Subject: Final Report - DER 83-51
A 50.55(e) Reportable Condition Relating to Unit 1 Auxiliary
Feedwater Pump Failed To Meet Requirements of Hot Functional
Tests.
File: 84-019-026; D.4.33.2

FINAL REPORT - DER 83-51
DEFICIENCY EVALUATION REPORT 50.55(e)
ARIZONA PUBLIC SERVICE COMPANY (APS)
PVNGS UNIT 1

ORIGINAL TEST CONFIGURATION

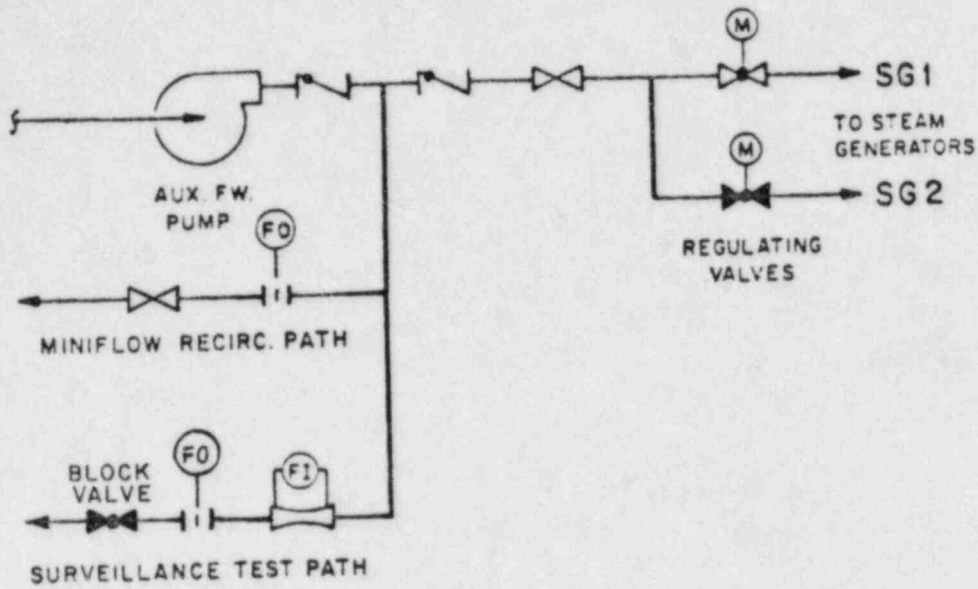
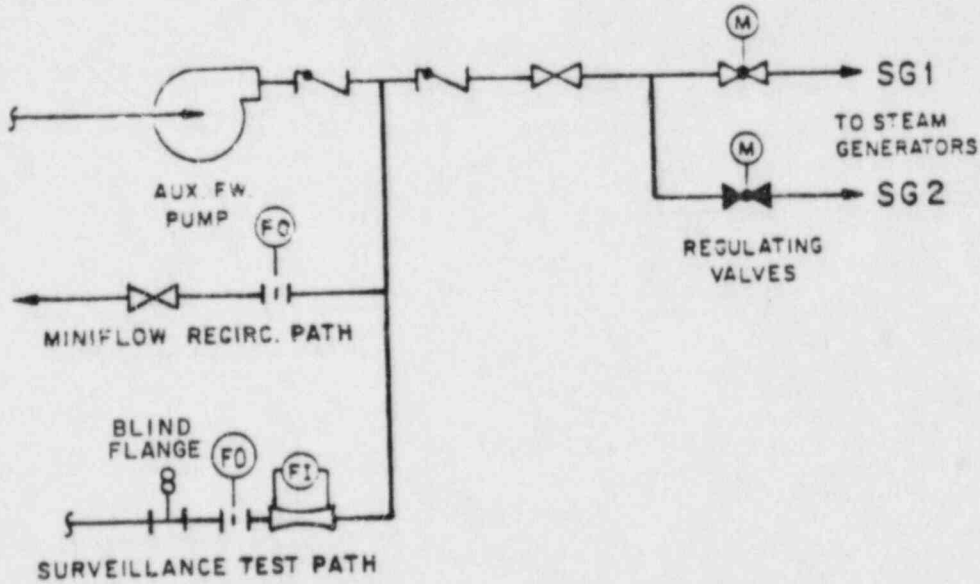
Further investigation revealed that the root cause of the deficiency was that the surveillance test path block valve 1PAFAV018 was leaking. This condition is noted on NCR SM2961. As a result of the leaking block valve, the flow to the steam generator was reduced.

The surveillance test path was provided to perform full flow, periodic testing of the pump. However, there are no requirements for a full flow surveillance test loop in the ASME Codes and the technical specifications. The overall system operability is demonstrated at 18-month intervals by directly pumping to the steam generators. Therefore a spectacle blind flange was installed in the surveillance path and the block valves were removed. The pump was tested again in the same configuration as before except for the addition of the spectacle blind flange to eliminate the leak path as shown in the attached sketch. Evaluation of the test data indicates that the pump can deliver the required flow at rated head.

Investigation of the leaking block valve indicated that the valve leakage was common to both the "A" train and "B" train block valves. Even though the valves were not designed for flow modulation, they had to be throttled to obtain the required flow rates during surveillance testing. The valves did not withstand the conditions that resulted from throttling and as a result, were damaged and leaked. The subject valves were designed for use as isolating valves. As such, the installation of these valves in the surveillance path is a case of misapplication and incorrect installation.

DCPs 1SM-AF-062, 2SM-AF-062, and 3CM-AF-062 have been issued to eliminate the surveillance path by removing the block valves and adding a spectacle blind flange. SARC� 1165 has been issued to delete reference to the surveillance flow path from the FSAR. These DCPs will be implemented prior to fuel load in each unit.
